MINERALS PROGRAM INSPECTION REPORT

MINE NAME: Cresson Project	MINE/PROSPECTING ID#: M-1980-244	MINERAL: Gold and silver	COUNTY: Teller
INSPECTION TYPE: Monitoring	WEATHER: Clear	INSP. DATE: August 24, 2023	INSP. TIME: 09:30
OPERATOR: Cripple Creek & Victor Gold Mining Company	OPERATOR REPRESENTATIVE: Katie Blake, Brian Doering, Josh Adams	TYPE OF OPERATION: 112d-3 - Designated Mining Operation	
REASON FOR INSPECTION: Normal I&E Program	BOND CALCULATION TYPE:	BOND AMOUNT: \$209,491,188.00	
DATE OF COMPLAINT: NA	POST INSP. CONTACTS: None	JOINT INSP. AGENCY: None	
INSPECTOR(S): Timothy Cazier, P.E.	INSPECTOR'S SIGNATURE: 	SIGNATURE DATE: September 26, 2023

Photo 1. WHEX Clay Borrow Area (Excavation on east end, looking NW)

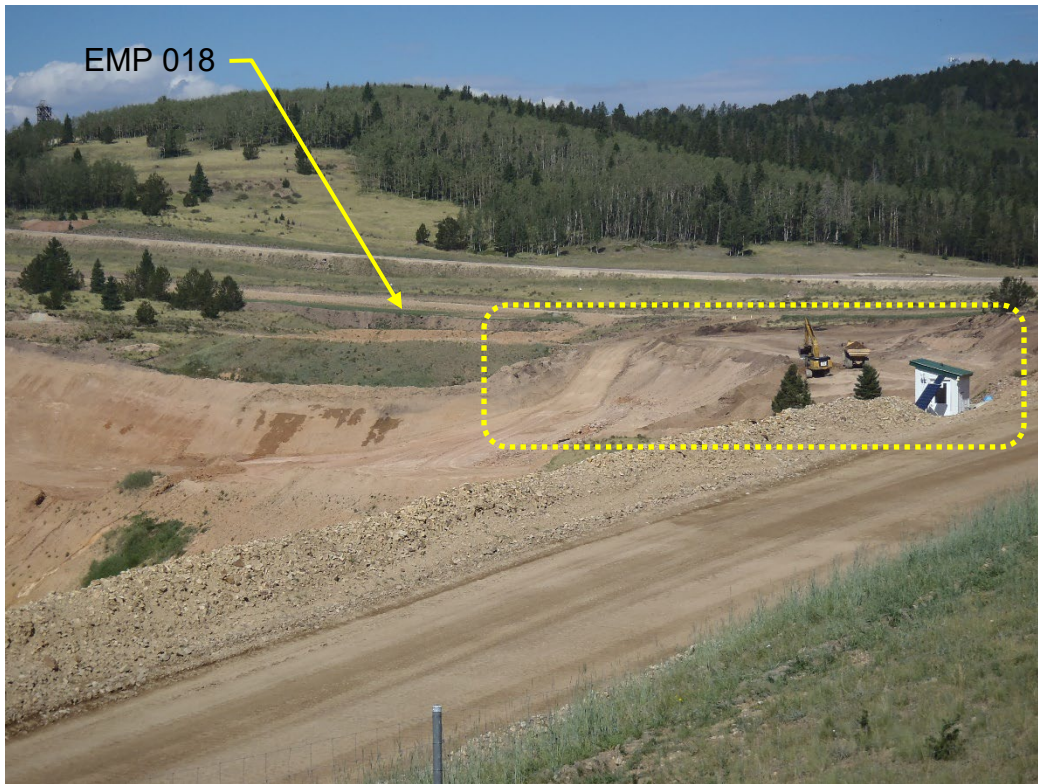
WHEX Clay Borrow Source: Ms. Blake and Messrs. Doering and Adams accompanied the DRMS to the WHEX Clay Borrow Source, along with two additional CC&V staff members. CC&V was continuing to extract clay from the borrow source (see **Photo 1**). Site representatives pointed out topsoil from this borrow source had been stripped and added to Topsoil Stockpile #38 (see **Photo 2**). They confirmed the additional salvaged topsoil would be included in the annual report topsoil accounting summary.

Photo 11. VLF1 Phase V washout material near Phase V pumps.

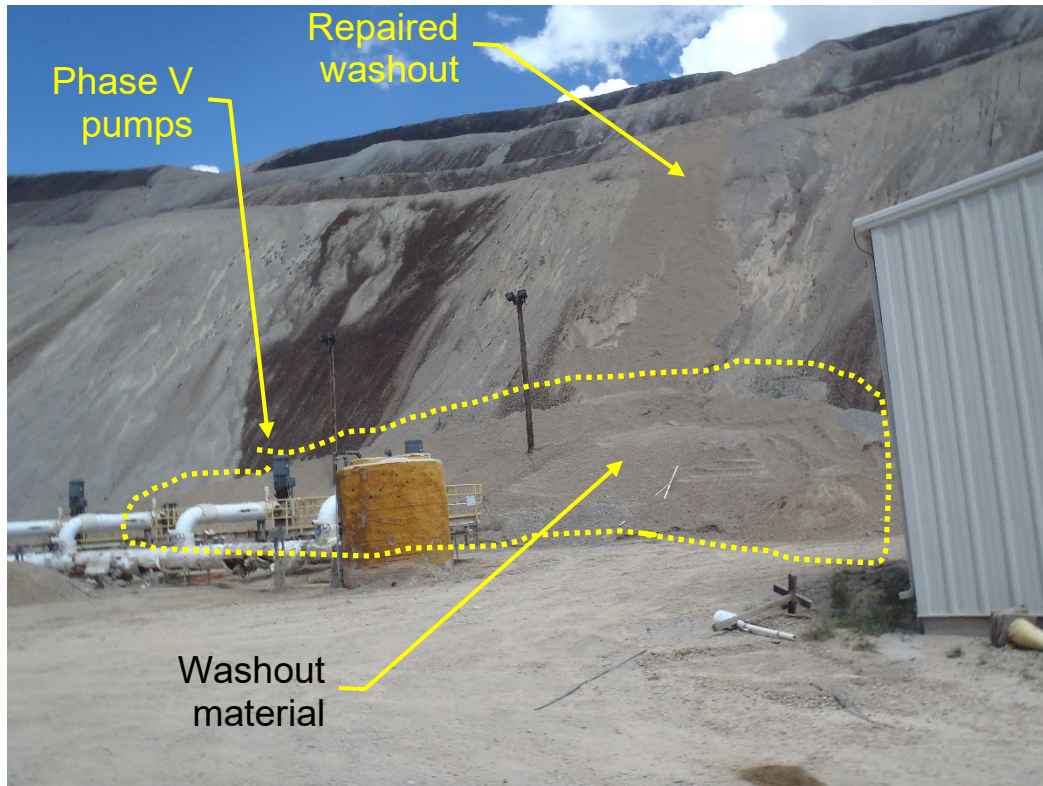
VLF 1 Phase V Washout: The VLF1 Phase V washout (see **Photo 10**) had been mostly repaired. A large amount of material from the washout ended up very close to the Phase V pumps (see **Photo 11**). Some of the washout material had been regraded to create a large "capture" berm to keep potential future washouts from impacting

the Phase V PSSA riser pipes. CC&V stated they were looking at the other PSSA riser locations for similar protection. A priority was thought to be the Phase IV risers, while the Phases I & II risers/pumps were not likely at risk. Mr. Dylan Noble (CC&V Projects) said CC&V was also moving header lines on VLF1 back away from the crests in feasible areas and grading the tops of the flats back away from the crests (again where feasible) so that that solution from future pipe failures would drain towards the center of the pad and away from the crest. I pointed out that although a good idea, it would have the potential to create large ponding areas that would conflict with the approved wildlife protection plan. He indicated they were aware of that potential.
